Side FlangeModification Reference for TOYOTA Supra JZA80 2JZ-GTE Before Minor Change 6MT

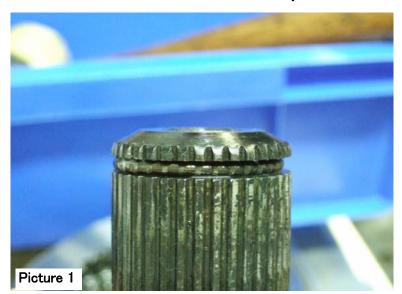
On the top of TOYOTA OEM side flanges for JZA80 2JZ-GTE Before Minor Change 6MT have a protruding area (trapezoid seen from the side) shown as Picture 1.

The protruding area interferes with the OS GIKEN Super Lock LSD inside parts.

Please shave the protruding aprea flat shown as Picture 2 and 3.
